**Re: Alice Townhomes, 5900 Alice NE
Grading and Drainage Plan
Engineer's Stamp dated 9-16-14 (J18D043)
Certification Stamp Date: 07-16-15**

**Re: Alice Townhomes, 5600 Alice NE
Request For Permanente C.O. – Accepted for 60-day Temporary C.O.
Engineer's Stamp dated 5-04-13 (J18D043)
Certification Date: 6-15-15**

DRAWING TITLE
GRADING AND DRAINAGE PLAN

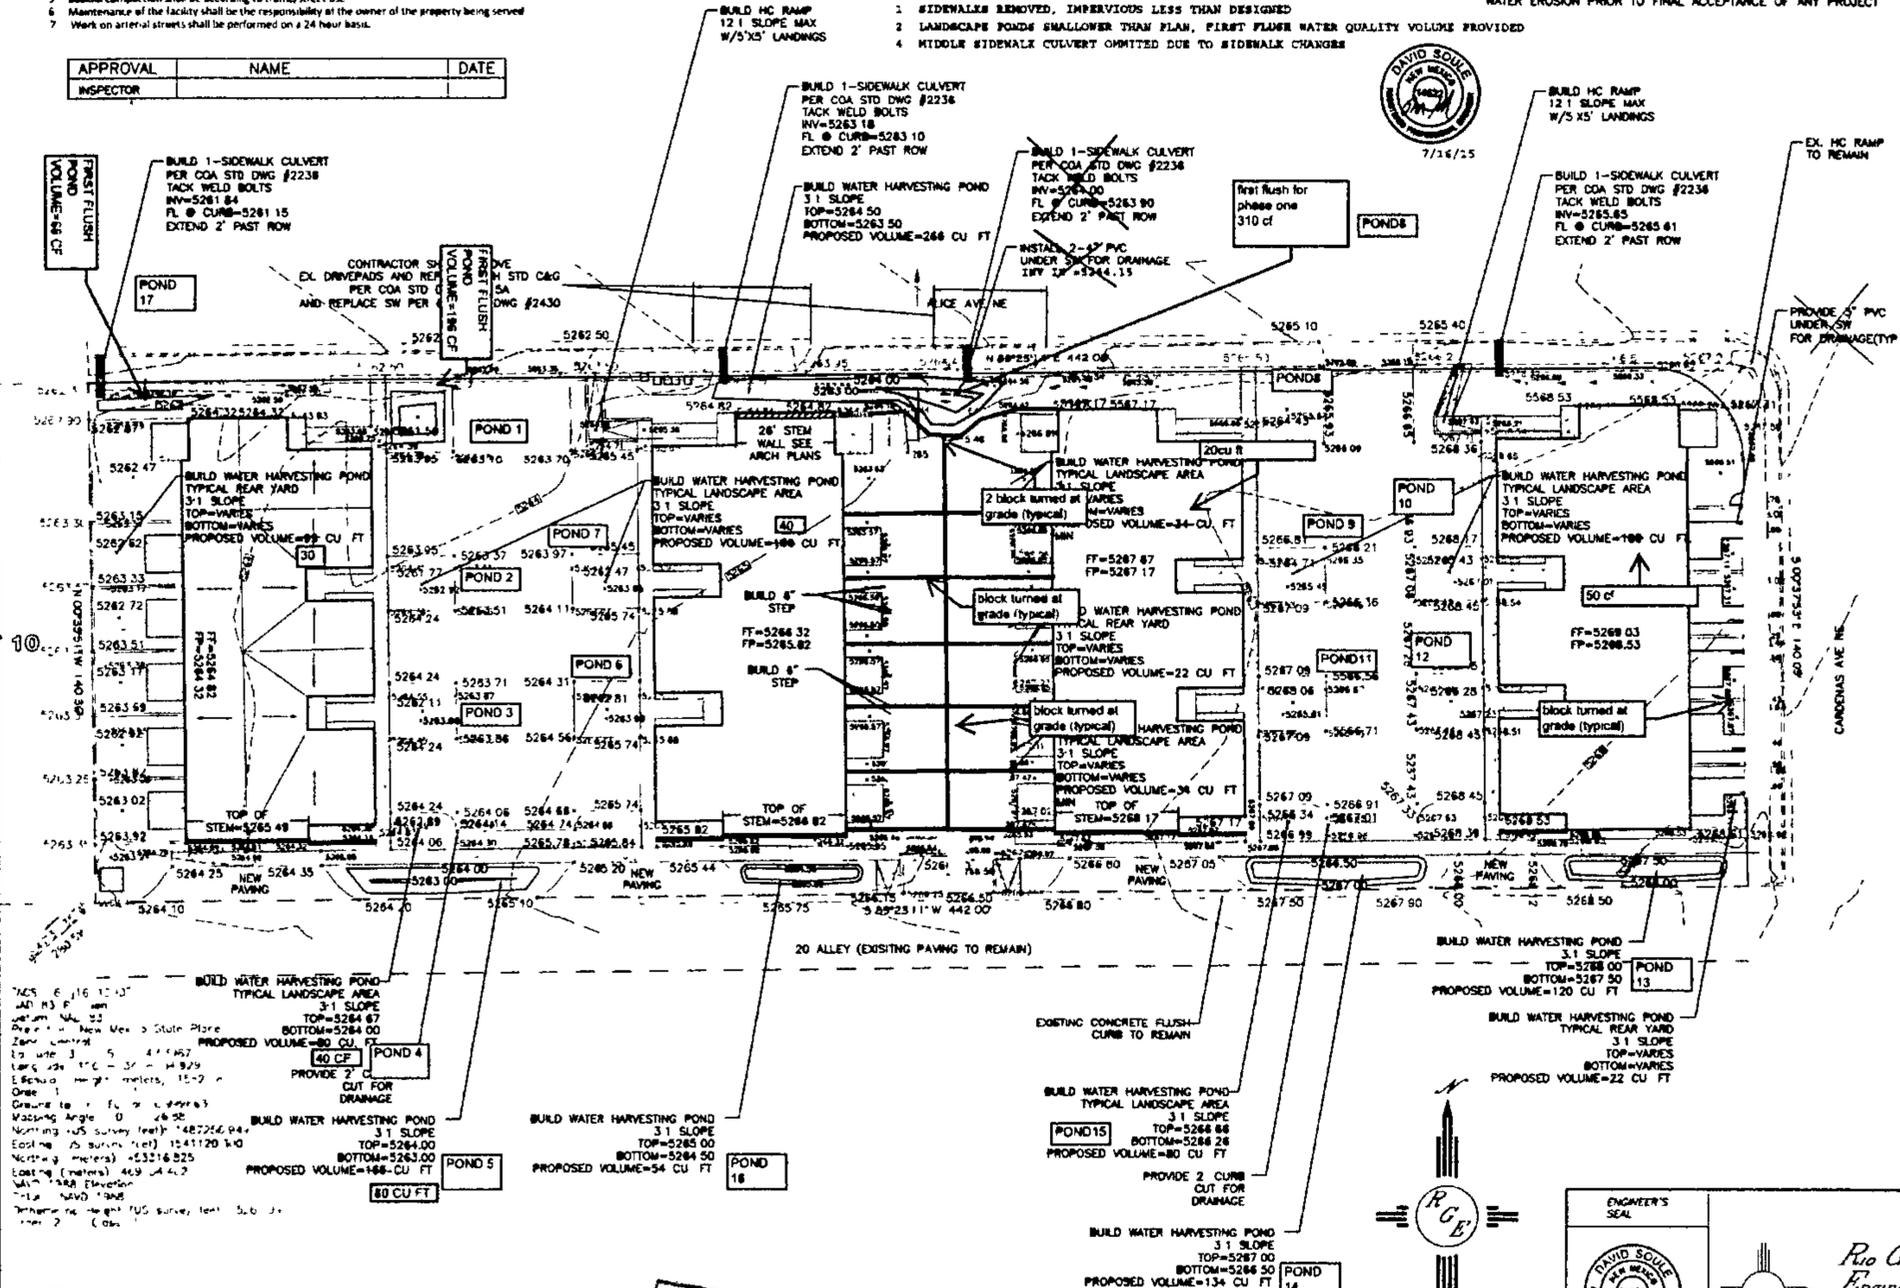
- No as-built elevations are provided for the ponds located to the south side of the buildings. **ALL EX PONDS SHOWN**
- It does not appear adequate ponding areas were created as it was shown on the grading plan (especially for the ponding area north of the building located in the middle of the project). **2077 PROVIDED 1297 REQ FOR FIRST FLUSH**
- Provide top and bottom areas/elevations for the pond including calculations to confirm the ponding volumes. **SPREADSHEET ATTACHED**
- An Administrative Amendment approval to the Site Plan for Building Permit is required for the changes behind the center buildings. **APPROVED AND SUBMITTED SEPERATELY**

- EXCEPTIONS**
1. SIDEWALKS REMOVED, IMPERVIOUS LESS THAN DESIGNED
 2. LANDSCAPE PONDS SMALLER THAN PLAN, FIRST FLUSH WATER QUALITY VOLUME PROVIDED
 4. MIDDLE SIDEWALK CULVERT OMITTED DUE TO SIDEWALK CHANGES
